Flex Fuel Extended Crank due to Alcohol Density Calculation

Service Category Engine/Hybrid System

Section Engine Control

YEAR(S)	MODEL(S)	ADDITIONAL INFORMATION
2012 – 2013	Sequoia	
2012 – 2013	Tundra

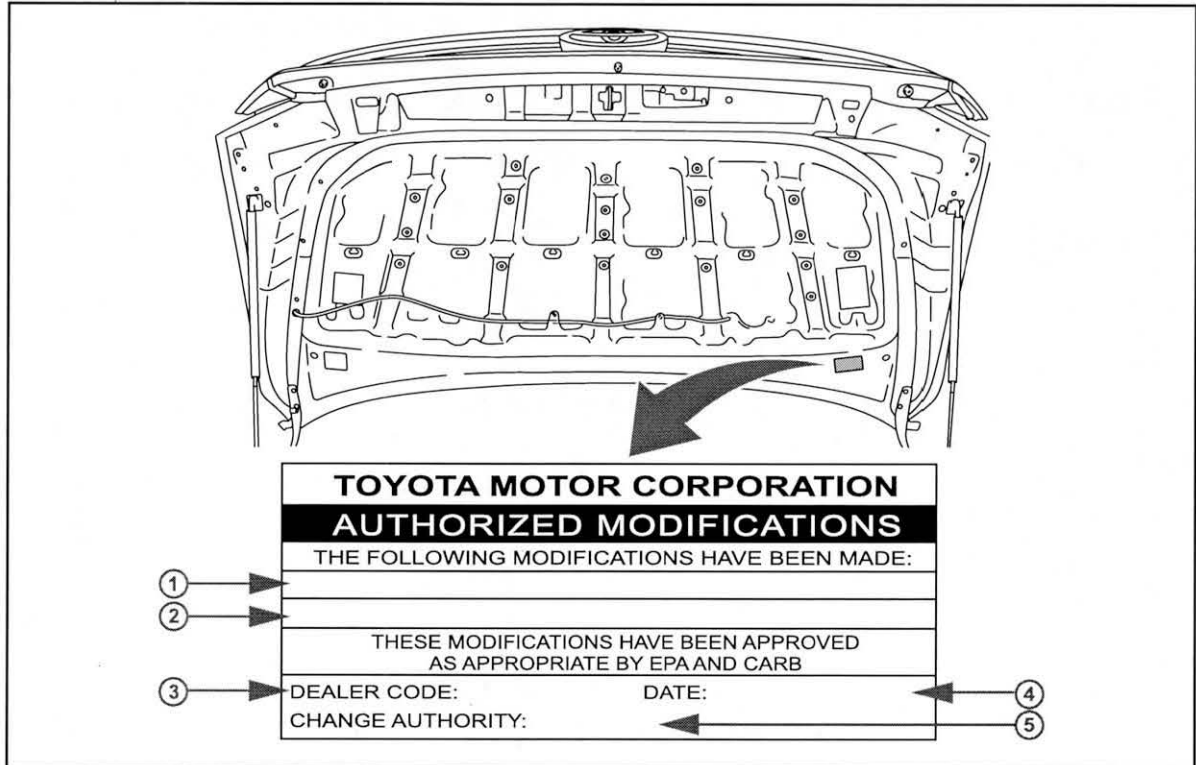
1. Confirm the difficult-to-start condition.
2. Using Techstream, confirm one or more of the following DTCs is present:
 - P1604: *Startability Malfunction*
 - P1605: *Rough Idling*
 - P0171: *System Too Lean (Bank 1)*
 - P0172: *System Too Rich (Bank 1)*
 - P0174: *System Too Lean (Bank 2)*
 - P0175: *System Too Rich (Bank 2)*
3. If any of the DTCs listed above is present, confirm the Alcohol Density Estimate and fuel trim values.

Is the Alcohol Density Estimate value 15% or greater and are the fuel trim values negative?

- **YES** — Reprogram the ECM (PCM). Go to step 4.
 - **NO** — This bulletin does NOT apply. Continue diagnosis using the applicable Repair Manual.
